Item Name: Quick Release Basket and Long Cargo Tube Mounting Provisions, Fits LH or RH

DART SERVICE INSTRUCTION

TO AMEND INSTALLATION INSTRUCTIONS D350-607-3 Rev.D,
INSTALLATION INSTRUCTIONS D350-607-4 Rev. C AND
INSTRUCTIONS FOR CONTINUED AIRWORTHINESS ICA-D350-607 REV. 6

A	NEW ISSUE	AJS	14.05.16
REV.	DESCRIPTION	BY	DATE
DESIGN	AJS	DART AEROSPACE LTD	
DRAWN	AJS	HAWKESBURY, ONTARIO, CANADA	
CHECKED		DRAWING NO.	REV. A
MFG. APPR.	N/A	DSI 9699	SHEET 1 OF 2
APPROVED		TITLE	SCALE
DE APPR.		LUG REPLACEMENT	NTS
DATE	14.05.16	COPYRIGHT © 2014 BY DART AEROSPACE LTD THIS DOCUMENT IS PRIVATE AND CONFIDENTIAL AND IS SUPPLIED ON THE EXPRESS CONDITION THAT IT IS NOT TO BE USED FOR ANY PURPOSE OR COPIED OR COMMUNICATED TO ANY OTHER PERSON WITHOUT WRITTEN PERMISSION FROM DART AEROSPACE LTD.

FIGURE 1: INSTALLATION OF D4775-041 FWD STRUT

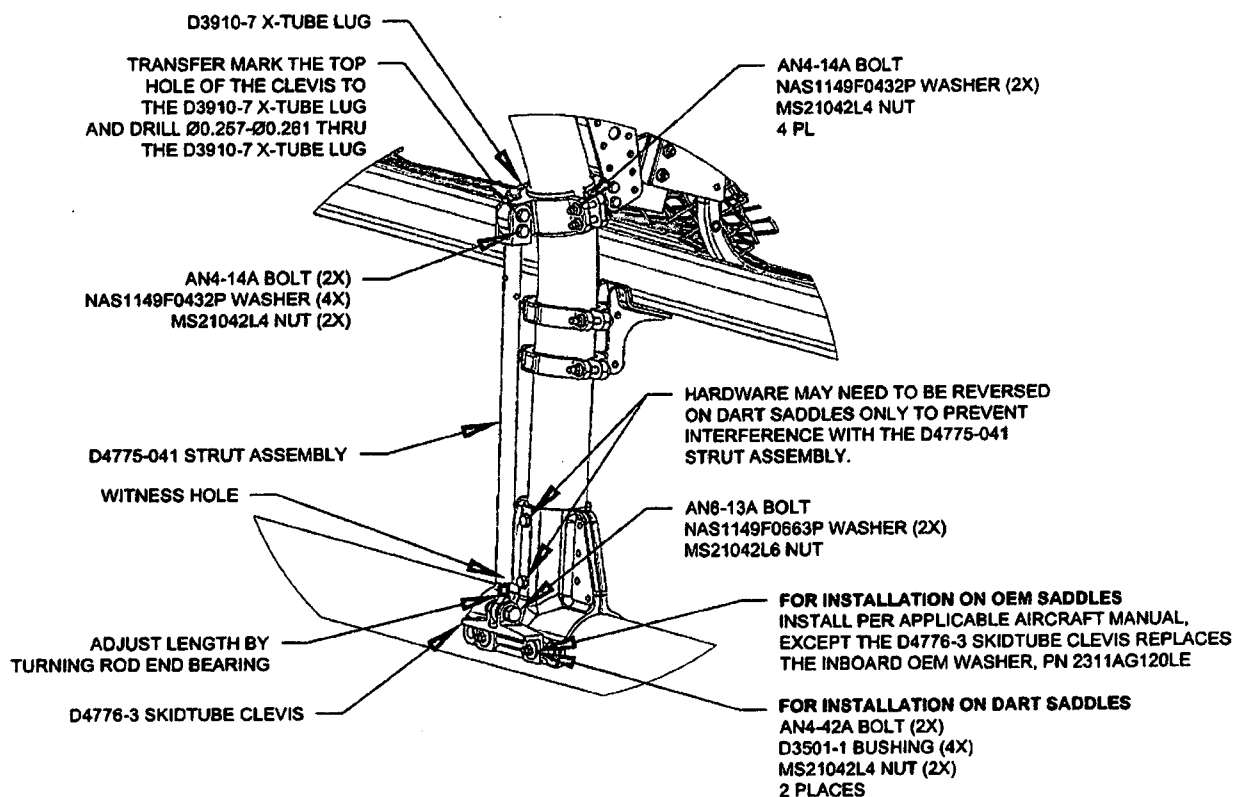
- 3.1 Substitute the Forward Lower D3910-5 X-Tube Lug with the D3910-7 X-Tube Lug as shown in Figure 1.
- 3.2 Install the forward D4775-041 Strut Assembly. Transfer mark from the upper hole on the clevis of the D4775-041 Strut Assembly to the D3910-7 X-tube Lug and drill thru the lug $\varnothing 0.257$ - $\varnothing 0.261$ as shown in Figure 1. Touch up chemical conversion coating per MIL-DTL-5541. Check the witness holes located at the bottom end of the D4775-041 Strut Assemblies to ensure that the thread from the rod end extends past the witness hole.
Torque MS21042L4/-4 nuts to 50-70 in-lbs (5.7-7.9 N-m). Torque MS21042L6/-6 nuts to 160-190 in-lbs (18.1-21.5 N-m).
- 3.3 Complete the installation in accordance with Installation Instructions D350-607-3 Rev. D or D350-607-4 Rev. C.
